The 4K ROM modification.

We now need All on the ROM instead of the RA2 jumper J4.

Mod-1:

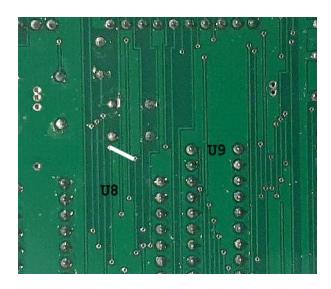
Remove jumper J4.
Connect U8-23 to U9-25.

To avoid mistakes with jumper J4 use this modification. Mod-2:

On component side, cut the track to R_A11.

Place a wire between the two All vias on the solder side.
